PLANNING, ZONING, & BUILDING DEPARTMENT  
PZ&B Staff Memorandum: Landmarks Preservation Commission

SUBJECT: HSB-23-007 124 PARC MONCEAU

MEETING: APRIL 17, 2024, LPC

**HSB-23-007 (ZON-23-095) 124 PARC MONCEAU.** The applicant, Parc Monceau Ltd (Peter Brooks, Representative), has filed an application requesting Landmarks Preservation Commission review and approval of a flood plain variance for improvements/rehabilitation of a designated historic building and approval for additions and renovations to an existing nonconforming historically significant building.

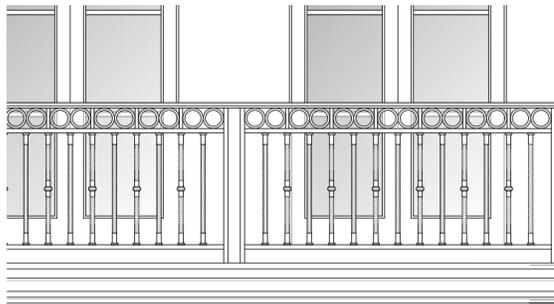
- Revised railing designs for the west elevation (as conditioned).
- Revised material for the back wall of the infinity pool for the west elevation (as conditioned).
- Addition of shutters to the west elevation.
